## REVISED RESPONSE TO REQUEST FOR ADDITIONAL INFORMATION

### APR1400 Design Certification

Docket No. 52-046

**RAI No.:** 176-8089  
**SRP Section:** 03.11 – Environmental Qualification of Mechanical and Electrical Equipment  
**Application Section:** 03.11  
**Date of RAI Issue:** 08/31/2015

Figure 3A-1 A Simplified Flowchart for Determination of Accident TIDs

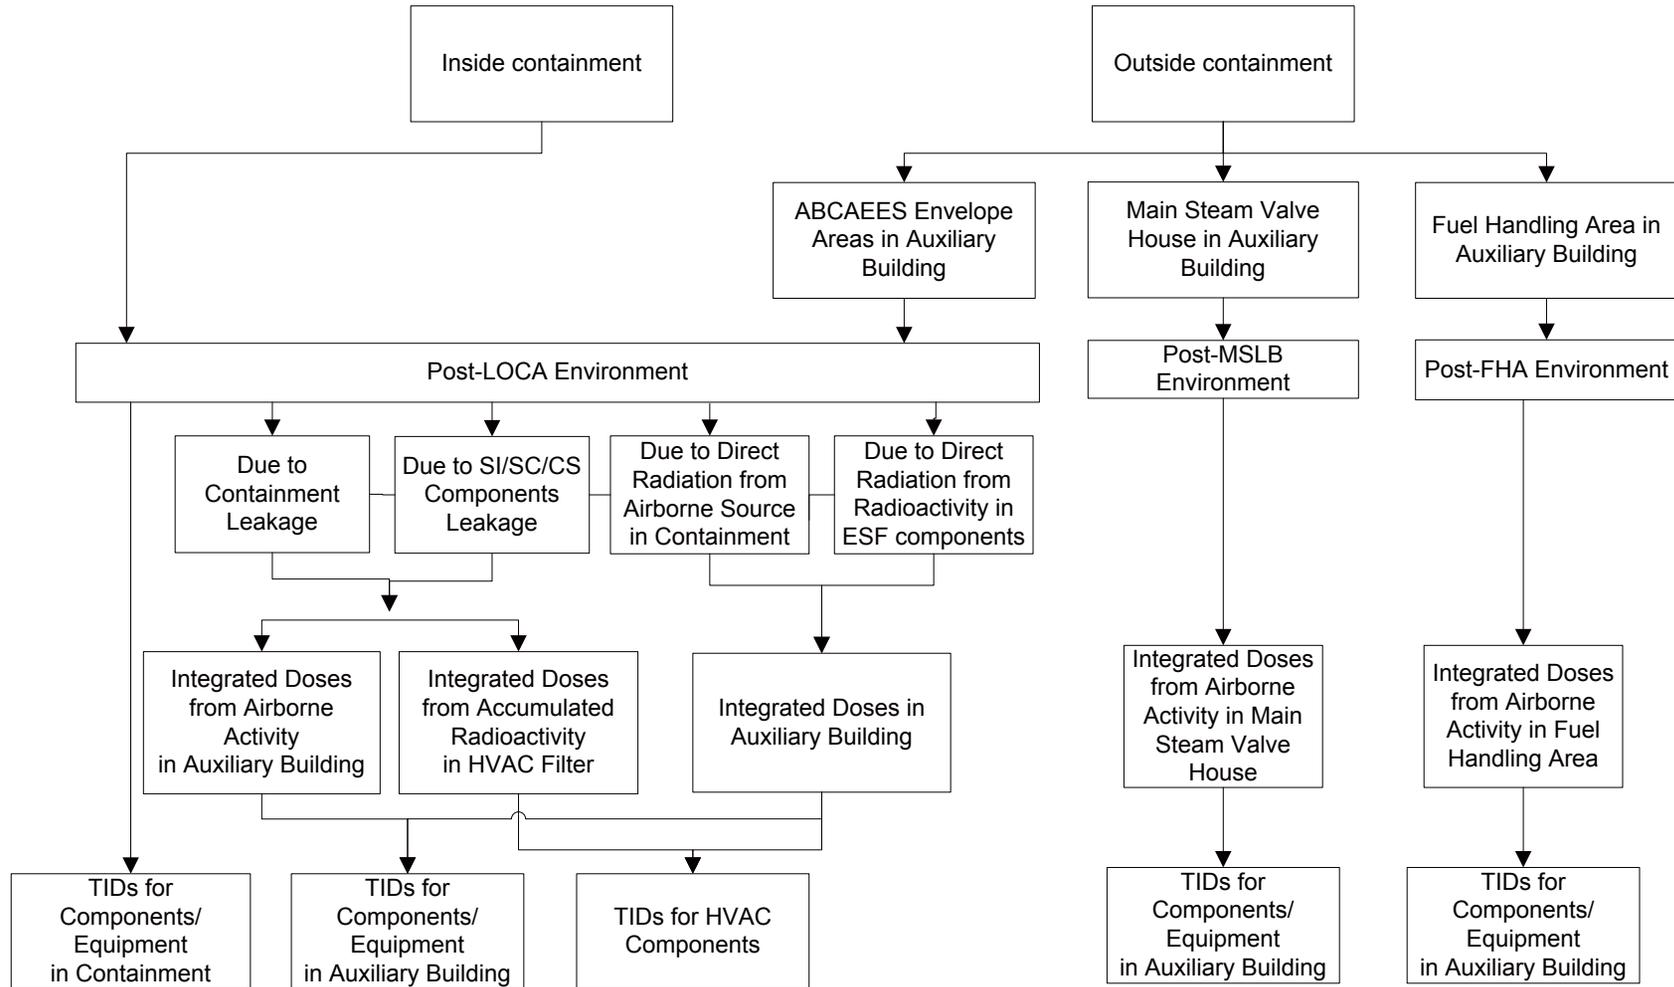
The appendix illustrates the methods, calculation models, inputs and assumptions for the determination of accident TIDs. A simplified flow chart for calculating the general TID for systems and components inside and outside the containment is presented in Figure 3A-1.

Figure 3A-2 RUNT-G Model to Calculate radioactivity in containment, IRWST sump, and walls

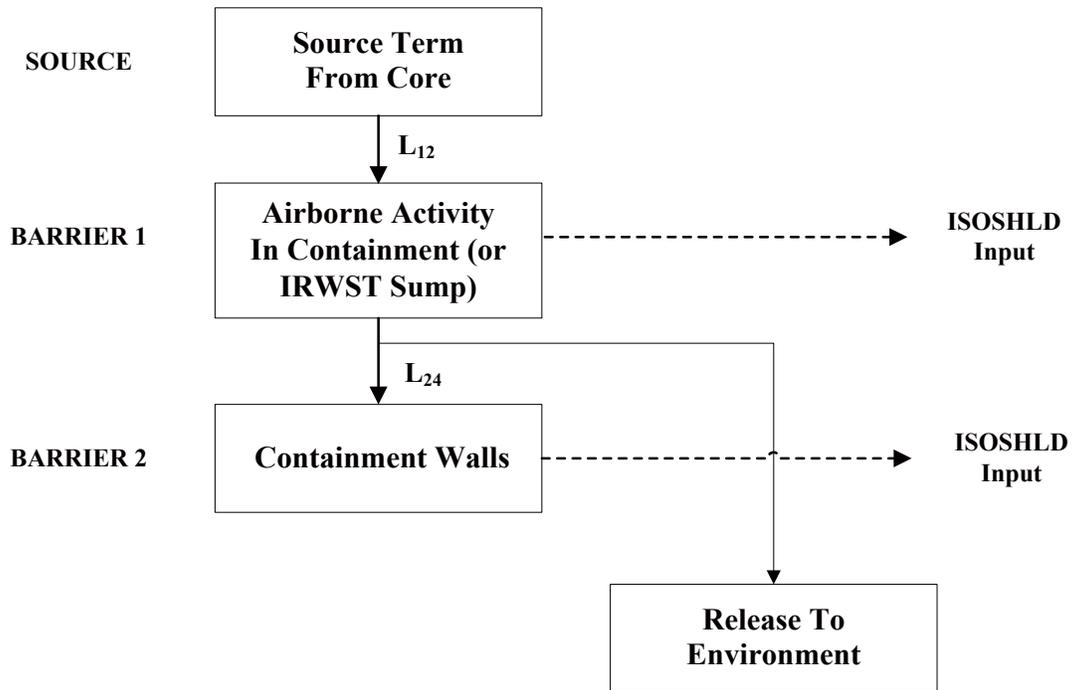
As shown in Figure 2 below, the RUNT-G model is developed to simulate the removal of the radioactivity in the containment atmosphere, in the IRWST sump, and on containment walls after the LOCA event.

Figure 3A-3 ISOSHLD Model for Dose Evaluation Inside Containment

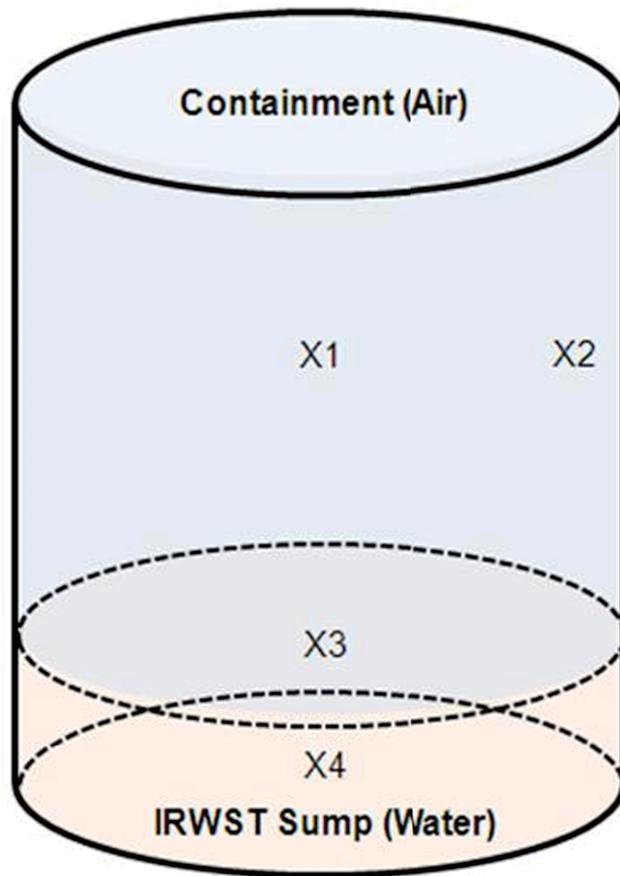
As illustrated in Figure B-3, the The activity distribution, or the locations inside containment at which the dose rate is calculated are as follows:

TIDs for the concentrations of radionuclides at different locations inside containment are determined using the ISOSHL D computer code which is incorporated in RUNT-G. As illustrated in Figure 3, the containment and the IRWST are modeled as a right cylinder with a free volume of  $3.128 \times 10^6 \text{ ft}^3$  ( $8.86 \times 10^{10} \text{ cm}^3$ ) with an inner diameter of 75 ft, and a right cylinder with a volume of  $8.61 \times 10^4 \text{ ft}^3$  ( $2.44 \times 10^9 \text{ cm}^3$ ) and effective height of cylinder of 4.87 ft, respectively. The radioactive materials released in the containment and IRWST sump are assumed to be uniformly distributed throughout the containment atmosphere and the IRWST sump.

- For the direct dose calculation from airborne radioactivity in containment, the containment is modeled as a right cylinder which has the same internal radius and volume as the assumed free volume as illustrated in Figure 3.

Figure 3A-4 RUNT-G Model for Containment Leakage

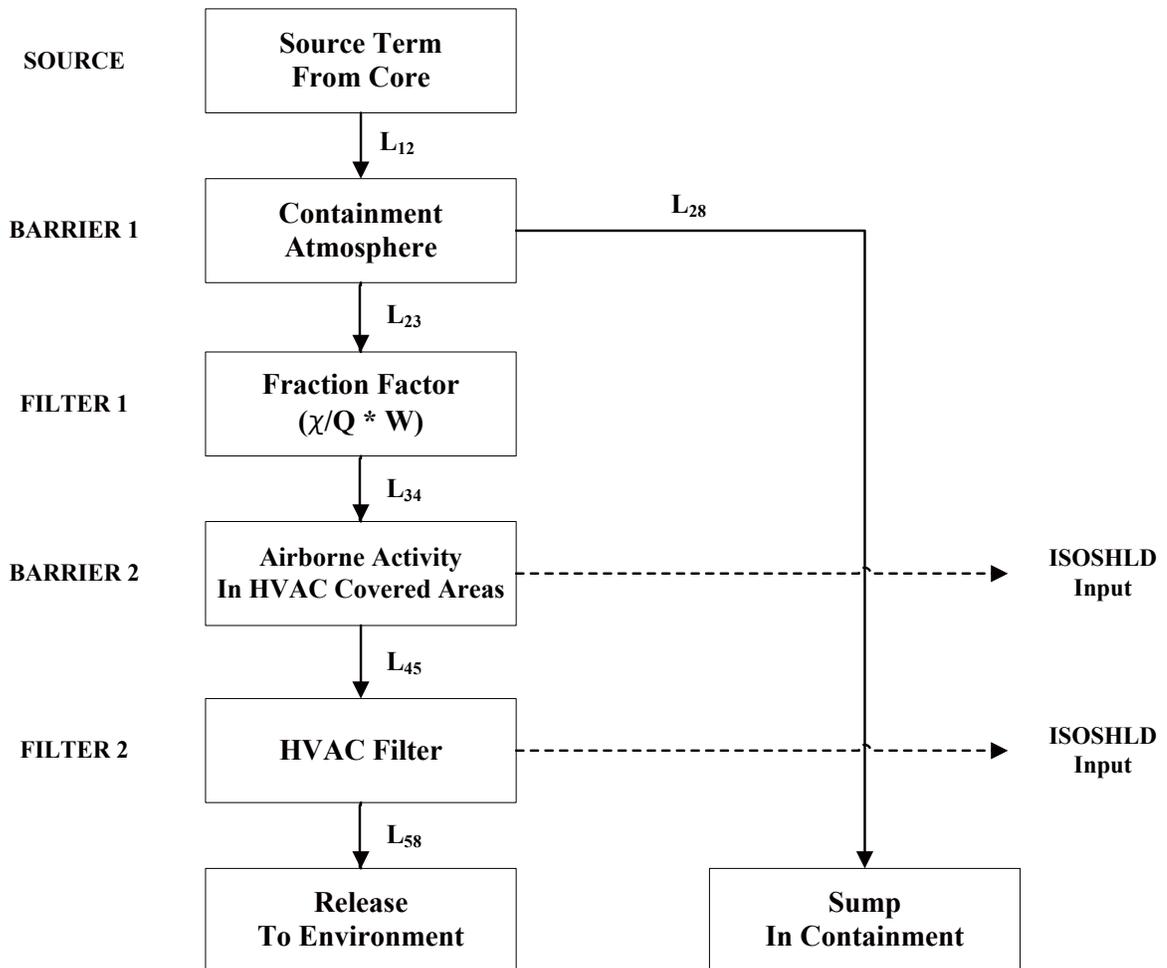
As shown in Figure 4 below, the RUNT-G model is developed to simulate the time-dependent leakage from containment, the dispersion in the atmosphere, and the intake to the auxiliary building.

This model is subdivided into three types as gaseous (includes noble gas & organic halogen), elemental and particulate halogen. For the first 24 hrs following a LOCA, the leak rate is assumed to be 0.1 %/day of containment volume and the leak rate is assumed to be 0.05 %/day thereafter (i.e., paths of  $L_{23}$  and  $L_{34}$ ). After the onset of the LOCA event, the wash-out phenomena by containment spray and natural deposition are taken into consideration as the leakage from BARRIER 1 to the sump (i.e., path of  $L_{28}$ ). These phenomena are only applicable to non-noble gases. The atmospheric dispersion and determination of the intake activity of the ABCAEES are calculated by using the fraction factor on FILTER 1, which is equal to the multiplication product ( $1.90 \times 10^{-3}$ ) of ( $\chi/Q$  (relative concentration of the plume,  $6.725 \times 10^{-4}$

Figure 3A-7 RUNT-G Model for SI/SC/CS Components Leakage

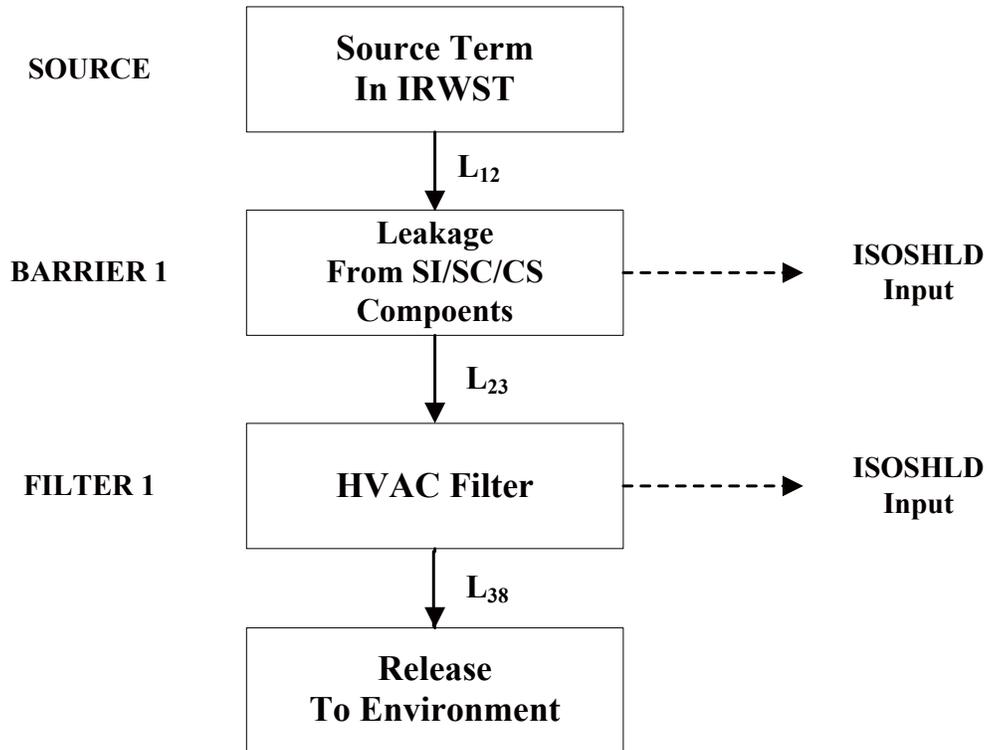
As shown in Figure 7, the RUNT-G model is developed to simulate the time-dependent leakage from SI/SC/CS equipment, which are located at elevation 55'-0" in the auxiliary building, and the atmospheric dispersion to the environment through the auxiliary building cubicles.

It is assumed that all the ESF leakages of 0.57 ft<sup>3</sup>/hr ( $1.61 \times 10^4$  cm<sup>3</sup>/hr) are retained on the floor of the corresponding compartments in the auxiliary building (i.e. BARRIER 1), and some of the iodines are flashed and become airborne in the auxiliary building. Then, the airborne iodine radioactivity in cubicles of the auxiliary building is released to the environment via the ABCAEES filter (i.e., paths of L<sub>23</sub> and L<sub>38</sub>). The release rate to the environment through the auxiliary building depends on cubicle volume and HVAC flow rate.

Figure 3A-8 RUNT-G Model for Direct Shine from Containment

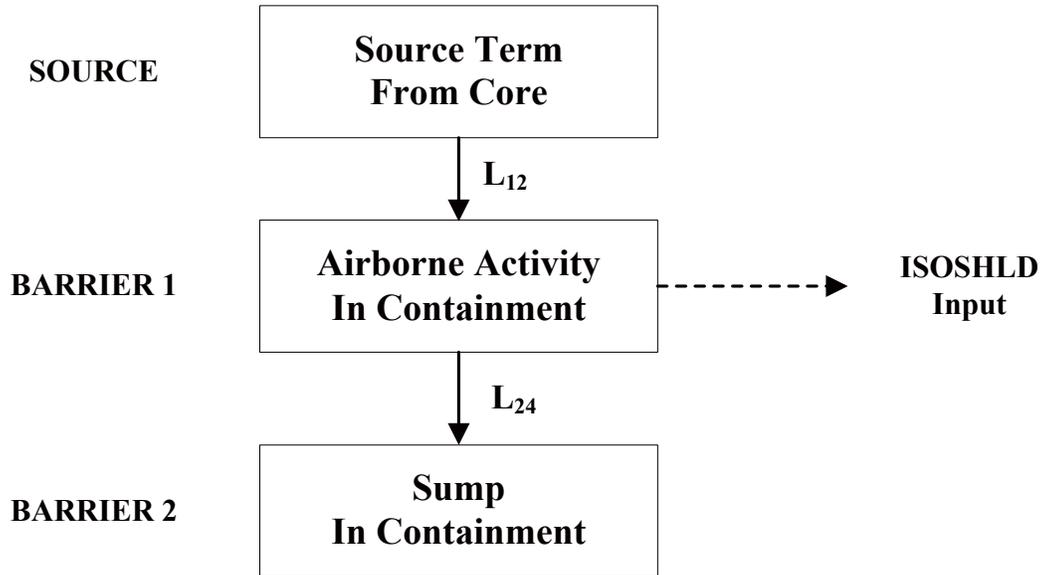
As shown in Figure 8, the RUNT-G model is developed to calculate the time-dependent activity in the containment, which is divided into three types as gaseous (includes noble gas & organic halogen), elemental and particulate halogen.

After the onset of the LOCA event, leakage from the core to the atmosphere of the containment is modeled as the leakage from the SOURCE to BARRIER 1 (i.e., path L<sub>12</sub>). The wash-out phenomena by containment spray and natural deposition are described as the leakage from BARRIER 1 to the sump (i.e., path L<sub>24</sub>), which are only applicable to non-noble gases.

Figure 3A-10 RUNT-G Model for Direct Shine from ESF Components

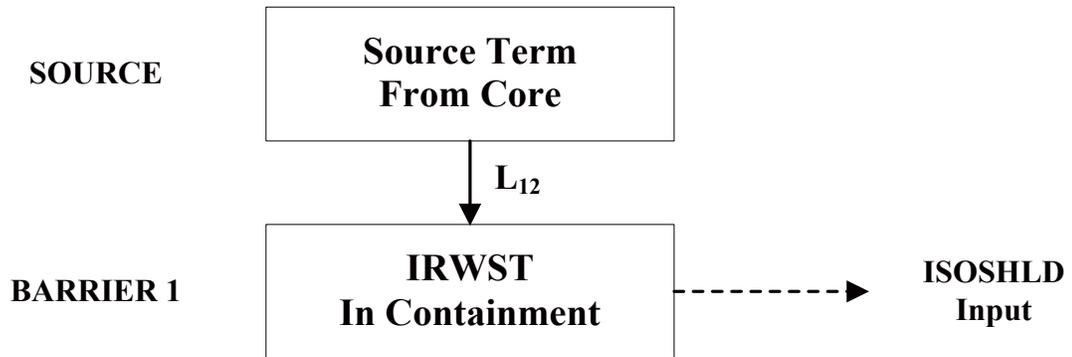
As shown in Figure 10, the RUNT-G model is developed to calculate the time-dependent IRWST source activity in containment. The radioactivity concentration in the IRWST water after the initiation of the LOCA event is used as the source term in SI/SC/CS circulating water.

Figure 3A-11 RUNT-G Model for Fuel Assembly Leakage

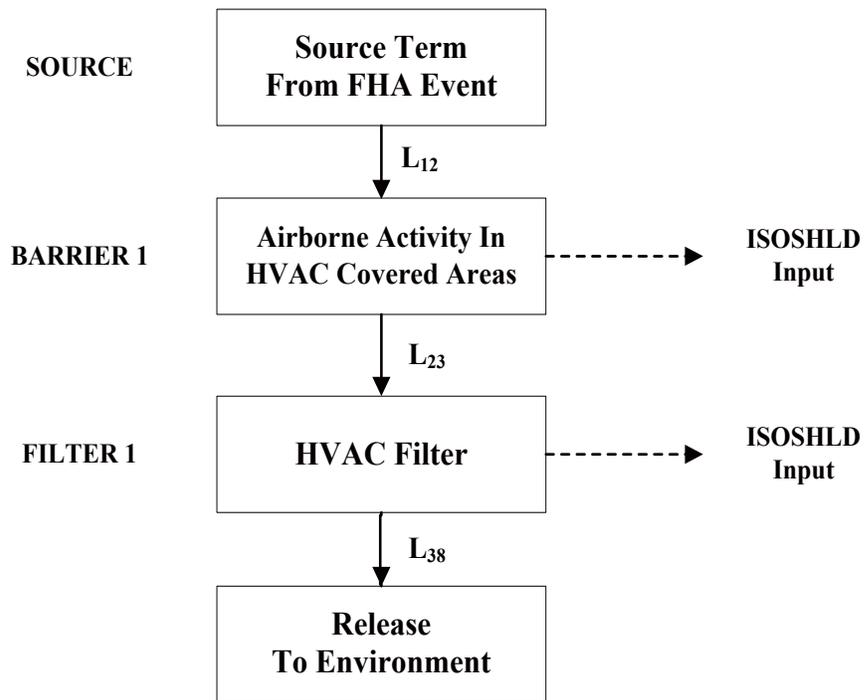
As shown in Figure 11, the RUNT-G model is developed to simulate time dependent activity in the fuel handling area after the onset of the FHA event.
